City of Portland, Maine - Building or Use Permit Application

Permit No: 10-1409	Issue Date:	CBL: 047 A013001
-----------------------	-------------	---------------------

Proposed Use: Commercial / Install two (2) 120 gallon gas tanks for temporary heat during construction	Proposed Project Description: Install two (2) 120 gallon gas tanks for temporary heat during construction
---	--

ADDENDUM TO SHEETS A3.01 & A4.01

SK1
REVISED

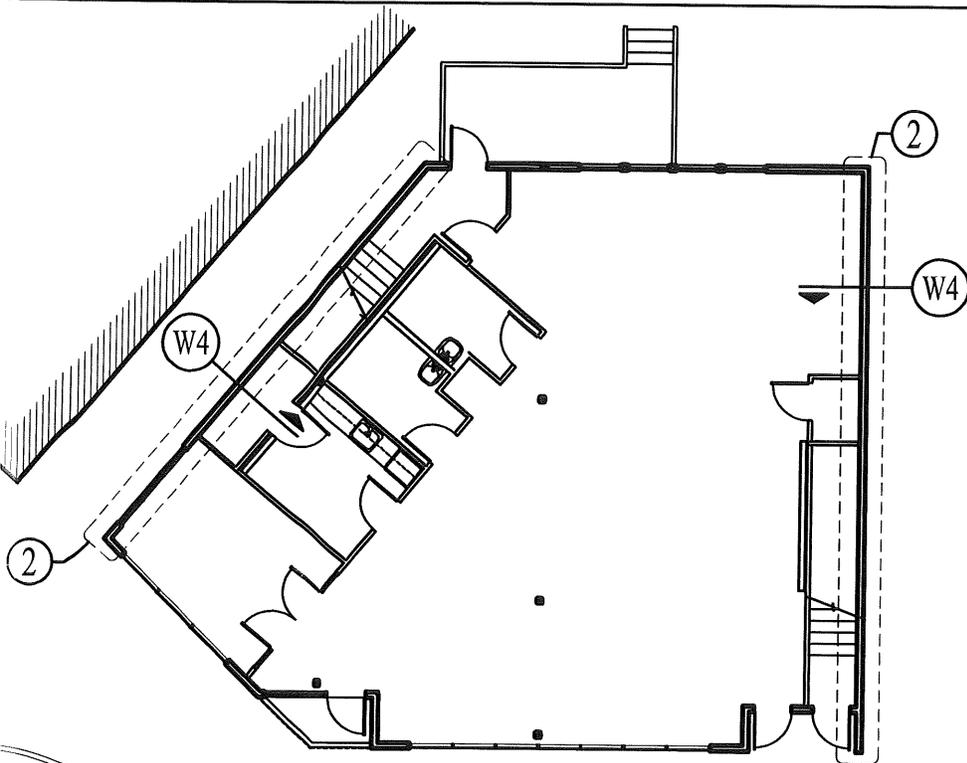
This looks good, however is there a typo in detail 2? The wording conflicts with the language at the top of the page and detail W4.

I was also thinking the structural engineer may need to weigh in on the roof rafter design on the bearing walls, will the attachment detail change as the rafter cannot sit on the wall plate?

Thanks, I have to remember, if not sprinkled, this applies to exterior walls that are within 5' of the property line or where openings are not permitted, or they must be protected.

I am issuing the attached sketch to the contractor to incorporate into the documents this revised wall assembly in accordance with the 704.11 provision for rated walls near a property line, and the continuation of the rating to the underside of the deck. The sketch achieves this as we have discussed.

Attached is a revised version of the wall construction along the property lines which you requested to have re-issued per the email below. As we discussed on the telephone back in September, as I remember it, the roof rafters are contained within the rated assembly, and therefore will rest on the wall plate without violating the required rating of the exterior wall. The interior gypsum board will be cut in and sealed at the web and flanges of all wood I-joists and will create a continuous rating from foundation to underside of roof decking.

ED OVER EXTERIOR WOOD SHEATHING AT EAST AND
S INTERIOR GYP TO BE RUN TO UNDERSIDE OF ROOF
OISTS.

DENSGLOSS GOLD EXTERIOR SHEATHING
WALLS AND INTERIOR
GYPSUM RUN TO UNDERSIDE
OF ROOF DECKING

SK-8

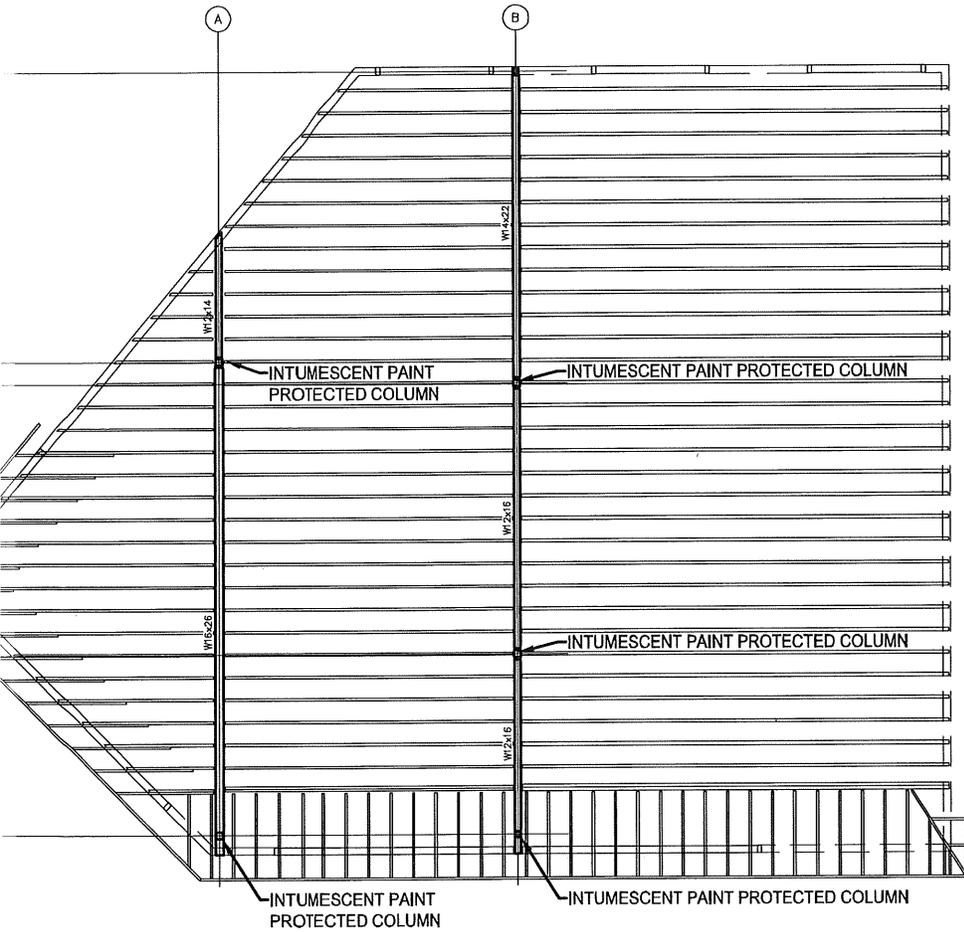
Thank you Jared,
Please provide the fire resistance classification UL design for each application and the product information.

>>> "Jared McKenna" <jared@archetypepa.com> 12/9/2010 4:00 PM >>>
Attached is SK8 for the Peloton Building at 795 Congress St. It shows Intumescent paint being applied to the exposed steel columns and beams to achieve a 1 hour fire rating.

FIRST FLOOR COLUMNS & BEAMS AND SECOND FLOOR COLUMNS TO BE PAINTED WITH "ALBI" INTUMESCENT PAINT AT A THICKNESS PROVIDING FOR A 1 HR FIRE PROTECTION.
